DOCUMENT 00 90 30
ADDENDUM No. 3

- A. The Construction Contract is known as:
SA009 – CIP – 12TH ST/CENTURY DR – PHASE 1
- B. Date of this Addendum: 2/13/2026

PP5

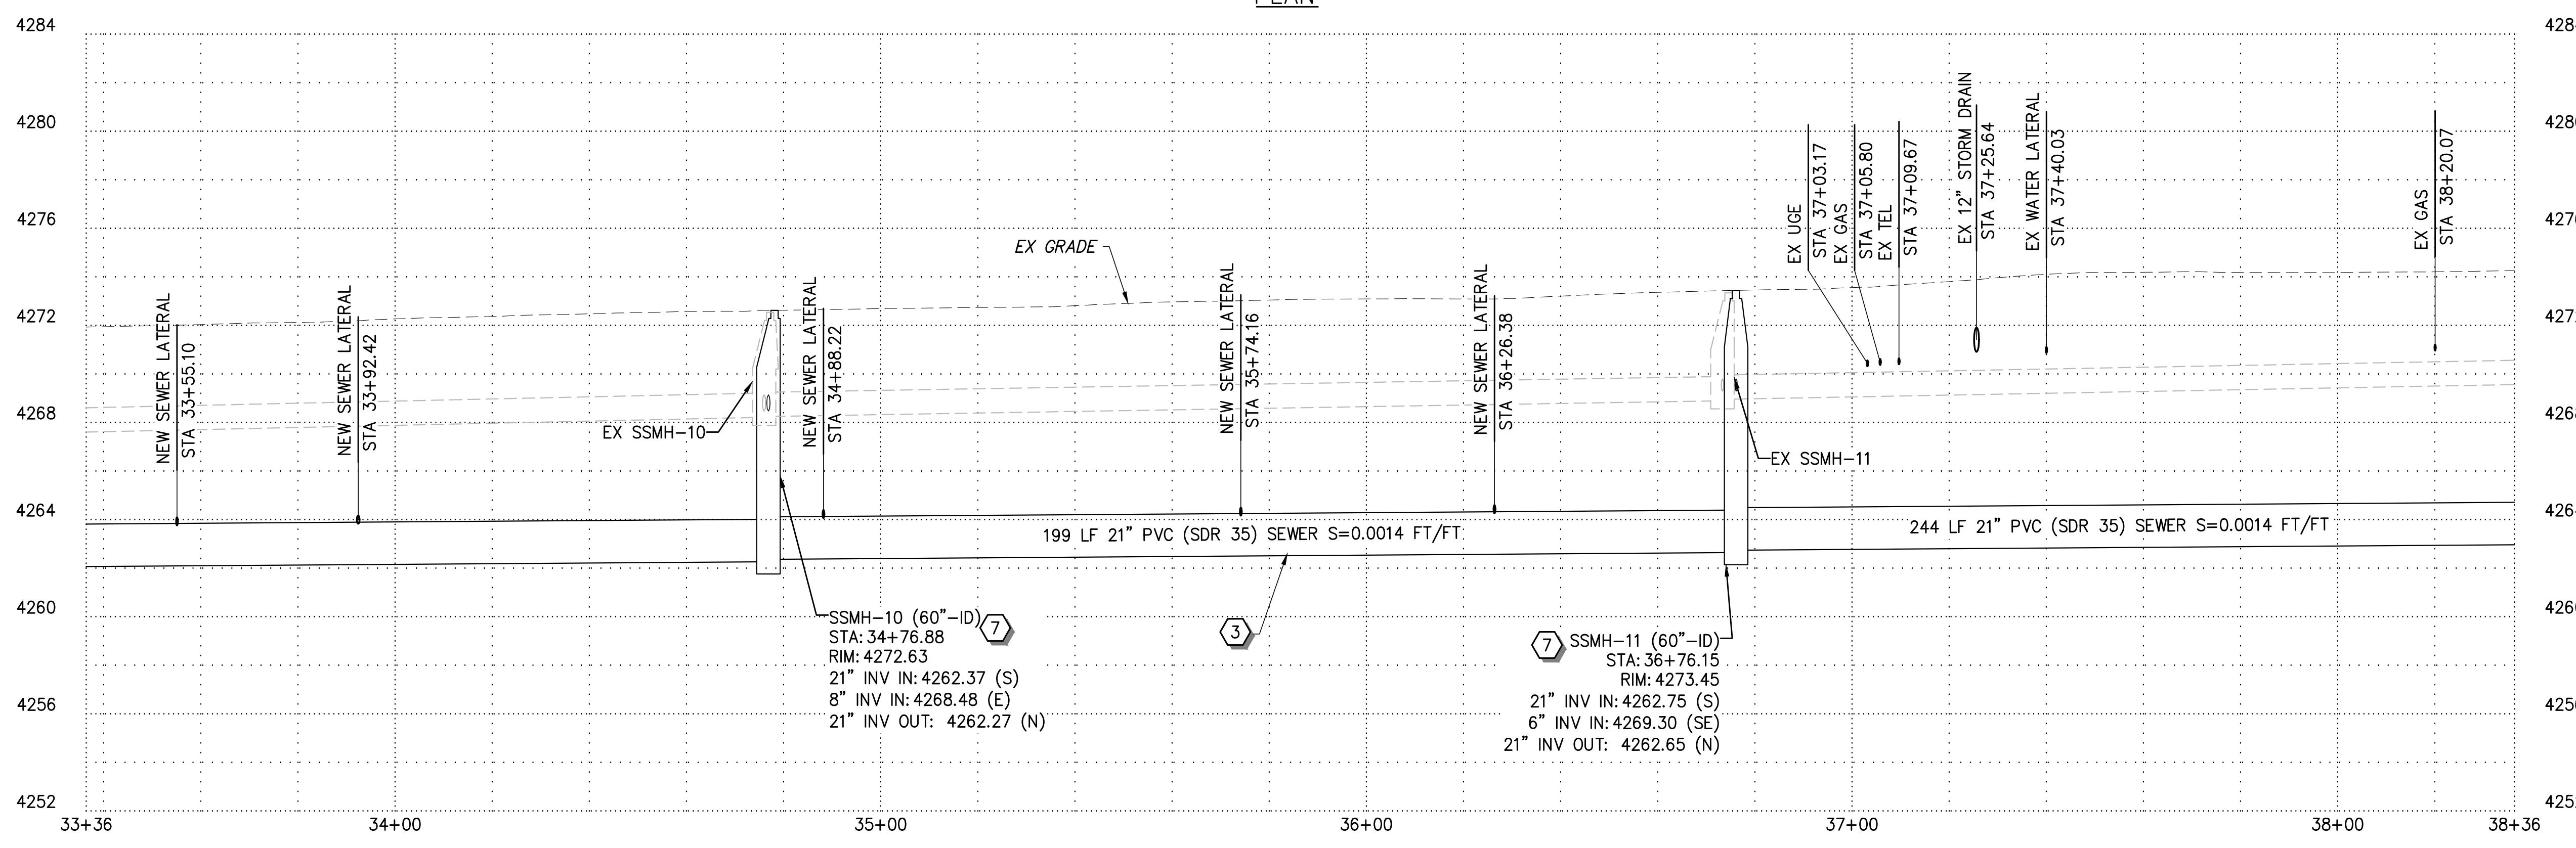
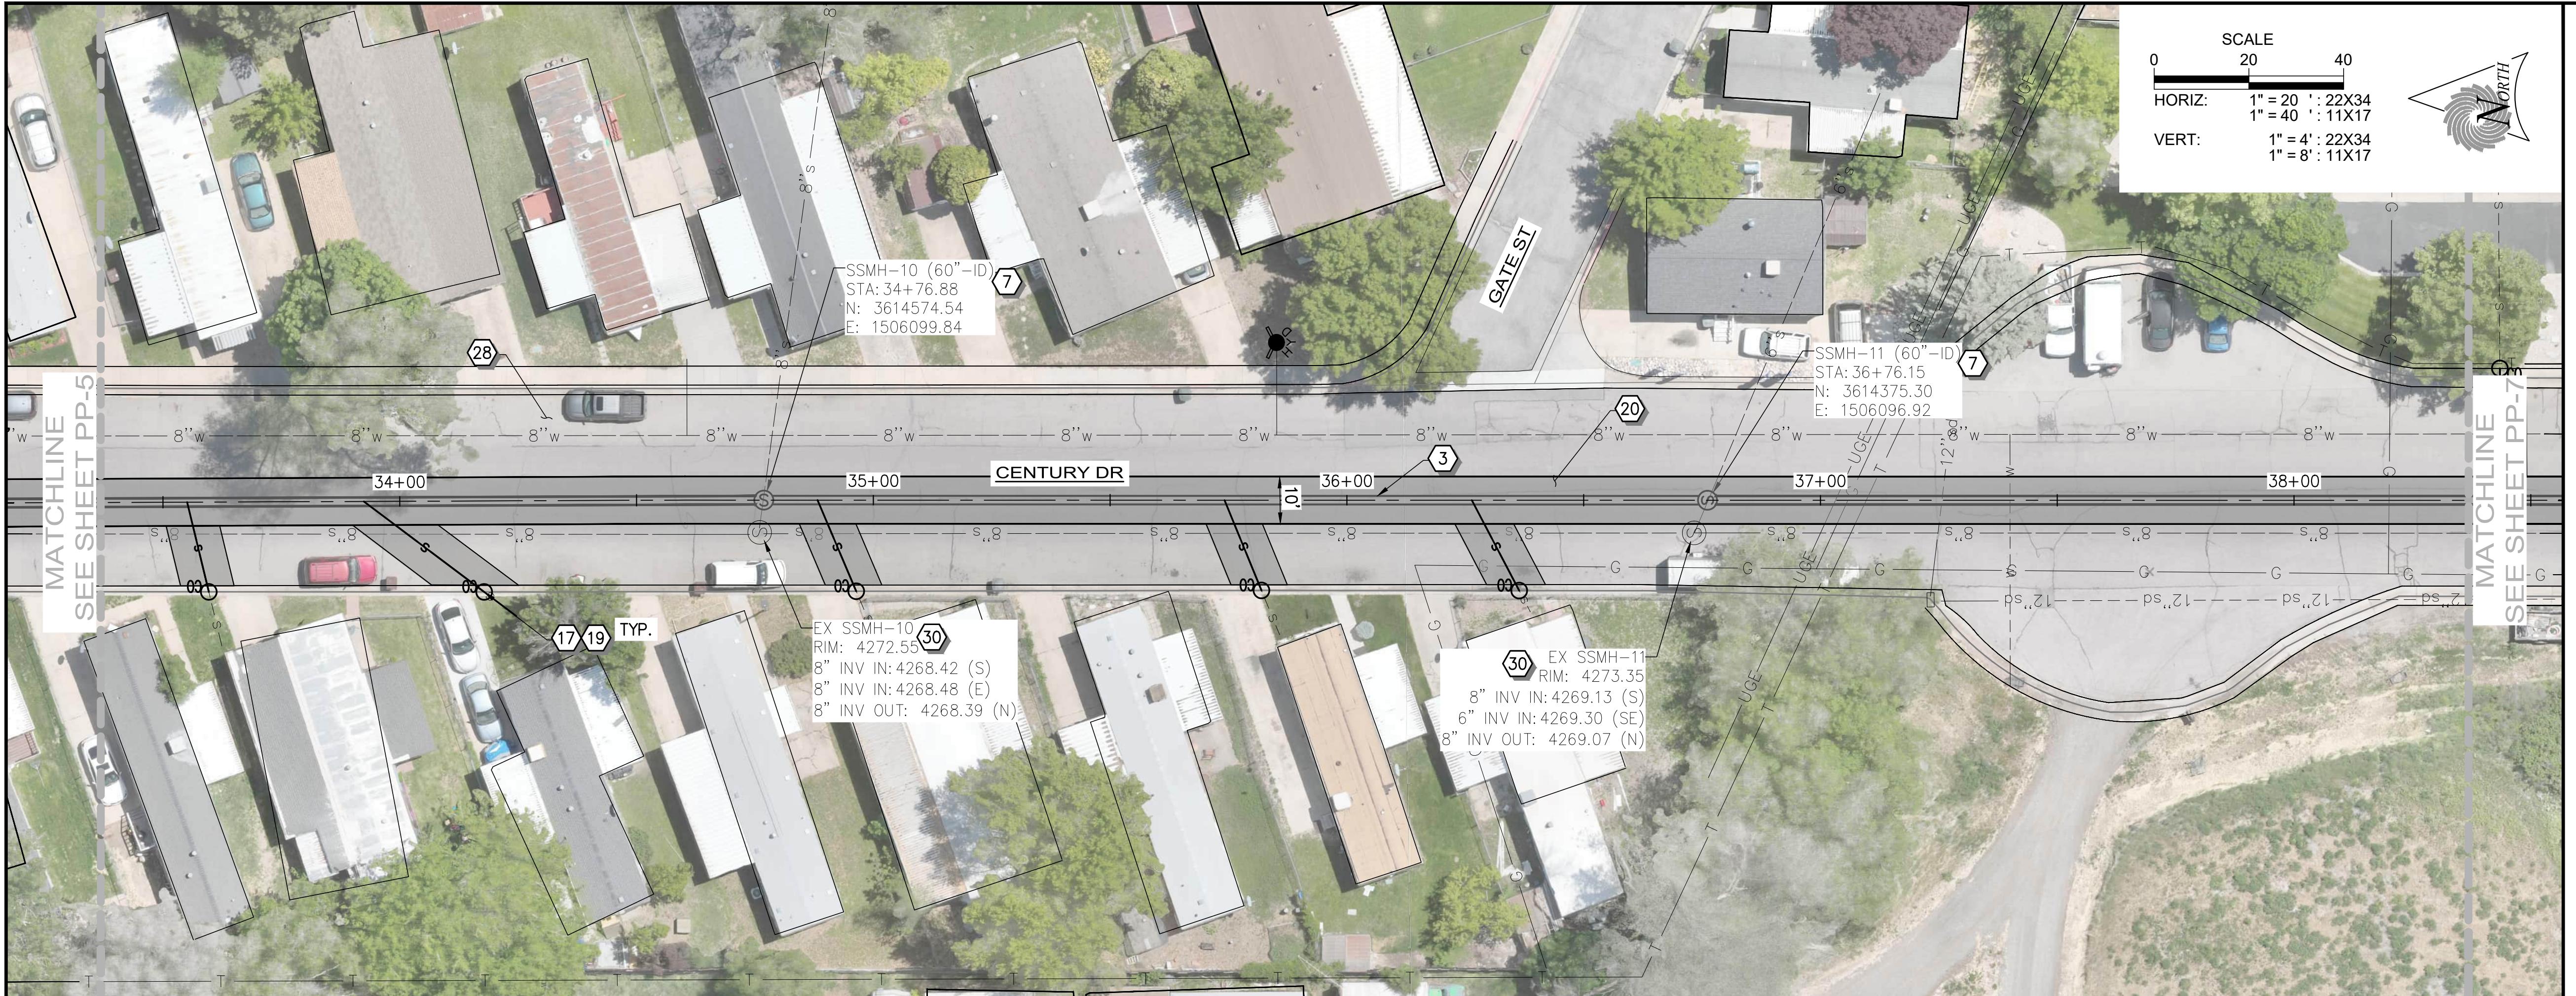
- A. Sheet PP-1 to PP-7 and C-1. Changed Construction Keynote 28 from "1" Mill and Overlay" to "2" Mill and Overlay"
